Xavier Rixhon's PhD thesis - Answers to jury members

Exploration of uncertainty-aware energy transition pathways -
Reinforcement learning and principal component analysis-based
methods

I would like to thank the jury members for the comments, which significantly helped improving the manuscript and substantiating the novelty of my work. Based on the notes taken during the private defense, I hereby transcribed, as accurately as possible, the jury's comments.

Figure 1: Storage installed capacities for the REF case

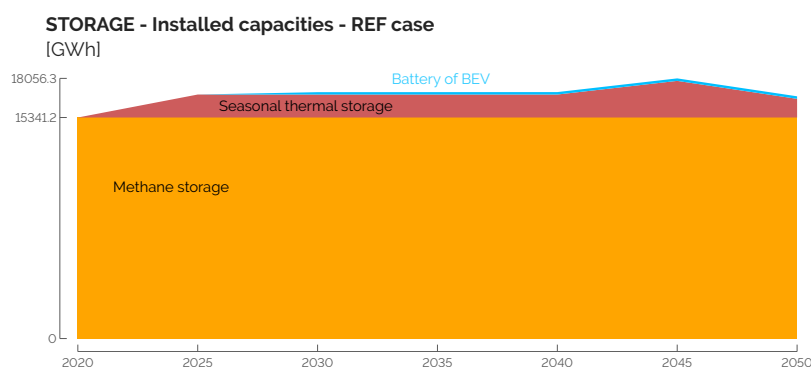
Stefan - Some big topics are missing like storage. Why is storage not more discussed?

As discussed during the private defense, storage is not more discussed in the manuscript for two reasons. First, the storage technologies, for the case of Belgium assuming a copper-plate approach, consist in two main technologies: methane storage mostly (about 15 TWh) and, to a smaller extent, seasonal thermal storage (about 3 TWh), with limited variations through the transition (see Figure 1). Analyses under uncertainties have not shown major variations neither. Second, storage assets are intrinsically linked to the conversion technologies and, consequently, can be seen as by-products of the optimisation results. For these two reasons, I have rather focused my analyses on the use of resources and the installation and operation of conversion technologies. Given the discussion during the private defense and these further explanations, I have not brought modification to the manuscript in this regard.

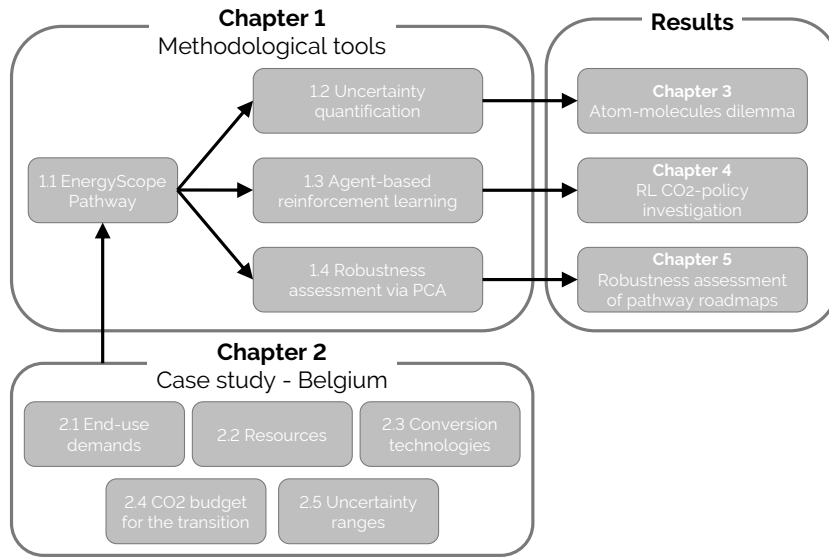
Stefano & Stefan - The thesis structure makes it quite difficult to follow. Having all the methodology summarised in Chapter 1, makes it difficult to link it to the different chapters. As changing the structure may be now a major work, I would invite you to think how to better connect the different parts.

Initially, I wanted to group methodology and results per kind of analysis, i.e., UQ on Pathway (Chapter 3), RL (Chapter 4) and PCA (Chapter 5) but that would have made the RL, and even more PCA, methodology parts come too far in the manuscript. For this reason, I made the choice to group all the methodological approaches together in Chapter 1 and the results in their respective chapters. Given this explanation, I have added one sentence [at the end of the introductory paragraph of the RL method in Chapter 1](#):

Finally, I have added a schematic at the end of the Introduction of the thesis to clarify the structure and highlight that Chapter 4 and 5 can be read after the methodological sections 1.3 and 1.4, respectively (see Figure 2).

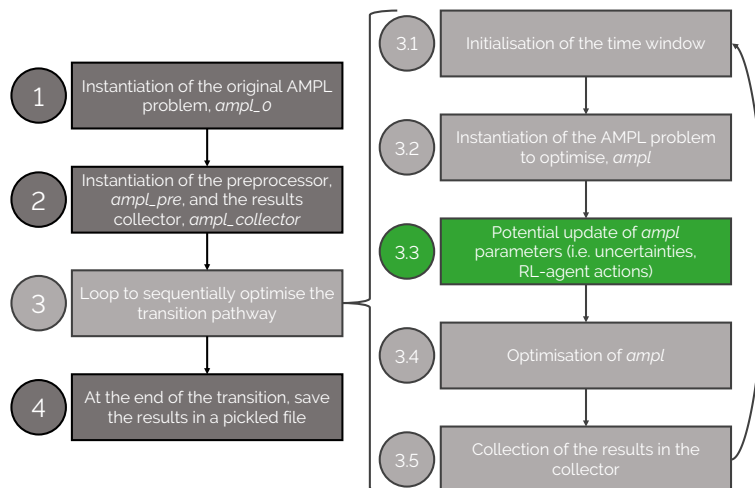
Christophe - Formal description of the problem is missing even in described in the text to make the link between the ideas and the implementation. Add some flow charts to introduce key elements

Stefano - p.17-19: is the myopic version modeled as a single LP or as a sequence of LPs? This should be better clarified. The diagram at p. 19 focuses on the code, it would be better replaced by a code showcasing the logic of the approach.

This point is addressed with the structure chart presented in the previous comment as well as the improvement of Figure 1.4 presenting the implementation of the myopic approach as well as the way uncertainties and RL change the values of some parameters (see Figure 3 of the present document).

Even though this sequence of LPs was already mentioned [in the caption of Figure 1.3](#), I have complemented the text [in the paragraph “Myopic pathway implementation” of Section 1.1.2](#),

and extended the caption of [Figure 1.4](#). However, besides highlighting the key step 3.3 where there is an update of parameters value, I have decided to keep the figure as is since, on the one hand, the extension of the caption provides now a better understanding and, on the other hand, the code itself is exactly what is schematically represented on the diagram.

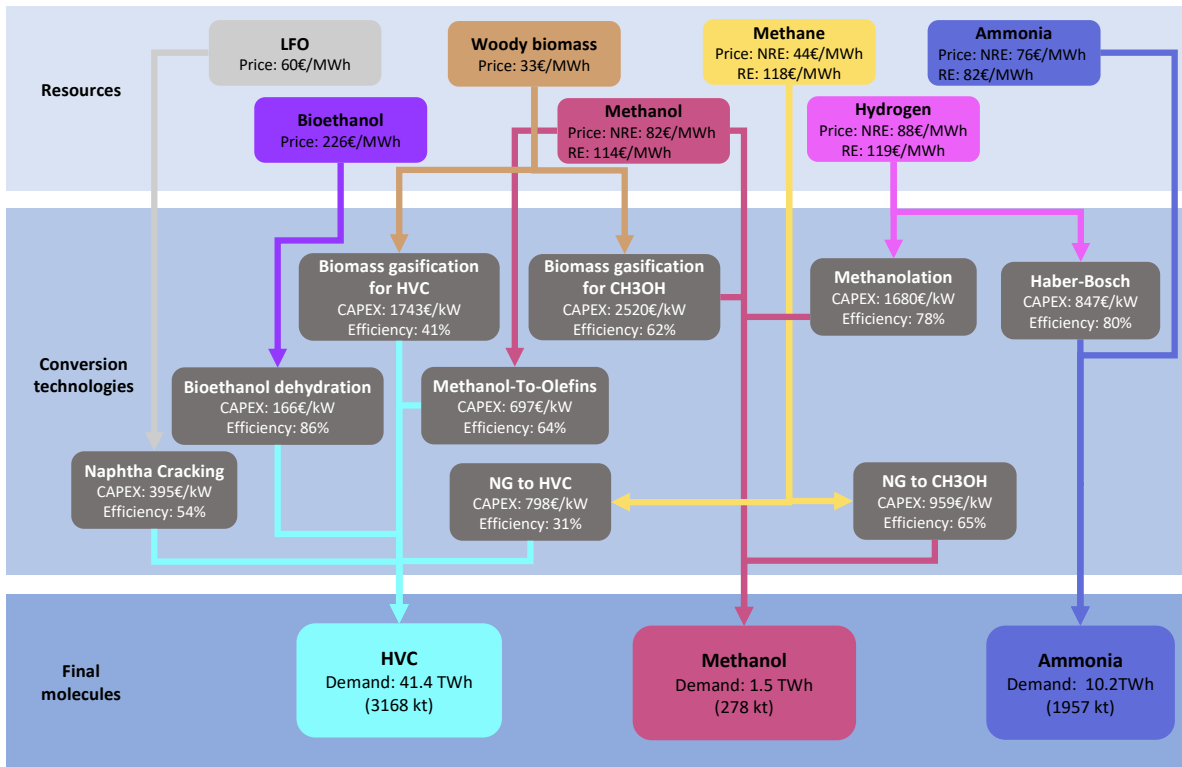
Stefano - Figure 2.5: What is the purpose of the violet line between “biomass gasification” and “methanolation”?

These were actually two different arrows, one pointing from “biomass gasification for CH₃OH” to “Methanol” and the other from “Methanolation” to “Methanol”. To avoid this confusion, the figure has been updated and the origin of these arrows are now on different vertical levels (see [Section 2.3](#)).

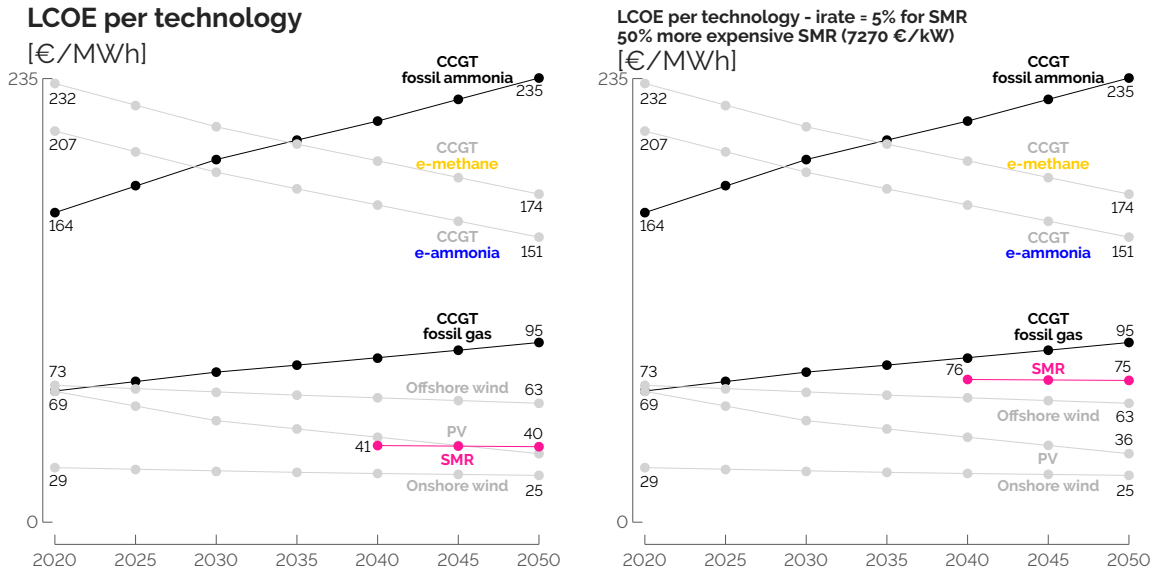
As discussed during the private defense, similarly to EnergyVille [17], we have considered the same CAPEX for SMR as the one considered for conventional nuclear power plants. Where EnergyVille considers a nominal CAPEX of 7500€/kW (like the current large Gen III design of Hinkley Point in the UK), we considered 4850€/kW like the CAPEX of conventional nuclear units in EnergyScope.

On top of the uncertainty applied to the CAPEX of SMR [-40%, 44%] considered in the thesis, I carried out a test on these assumptions by plotting the LCOE of electricity-production units considering different assumptions for SMR (see Figure 4.4). Even considering 50% more expensive SMR subject to a higher discount rate (5% versus 1.5% for the other technologies), we notice that SMR keeps on being more cost-competitive than other flexible production units, like e-ammonia CCGTs, that are substituted by SMR when the latter can be installed (see Chapter 3). In other words, it means that the optimistic values assumed for SMR in the thesis lead to a cheaper whole-energy system but does not affect its design, i.e., the installed technologies. Consequently, no further modification has been brought to the thesis regarding this comment.

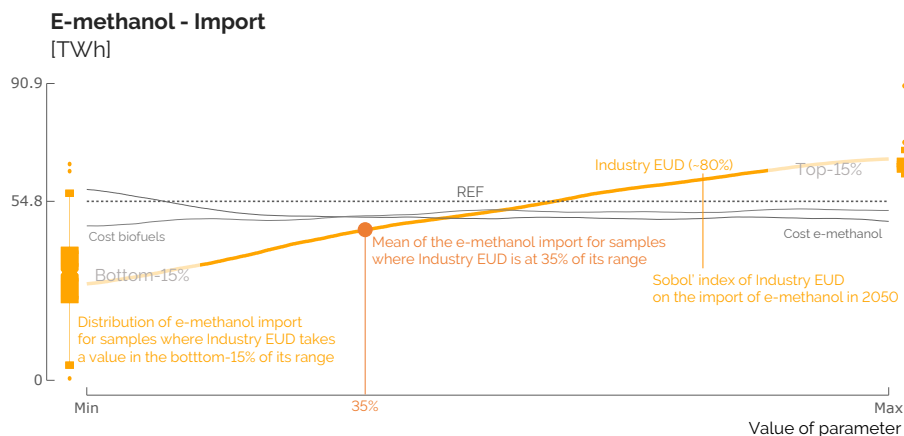
Stefano - p. 74, Figure 3.8: this graphs looks potentially interesting but it is not sufficiently well explained.

The objective of this set of figures is to point out the key parameters that drive the variation of some outputs of interest. Taking the case of Figure 3.8, we focus on the import of e-methanol in 2050. On the x-axis, we represent the value taken by the uncertain parameters in the different samples. As the range is not the same for all the parameters, we have limited this axis from “Min” to “Max”. The y-axis represents the feature of interest. The drawn lines represent average trend lines between the output of interest and one specific parameter. For the case of Industry EUD, for samples of the GSA where this uncertain parameter is at 35% of its range, the mean value of methanol imported in 2050 is roughly 50 TWh. The distributions present on the extreme left and right of the graphs correspond to the distributions of the output of interest for the samples of the GSA where the considered parameter takes a value in the bottom (left) or top (right) 15% of its range.

To improve the readability of this figure, I have updated the text zones to specify that these lines and distributions represent results of some specific samples of the GSA. Additionally, I have added a text zone to remind that the value between brackets is the Sobol’ index of the considered parameter regarding this specific output of interest, and added this information in the caption of the figure:
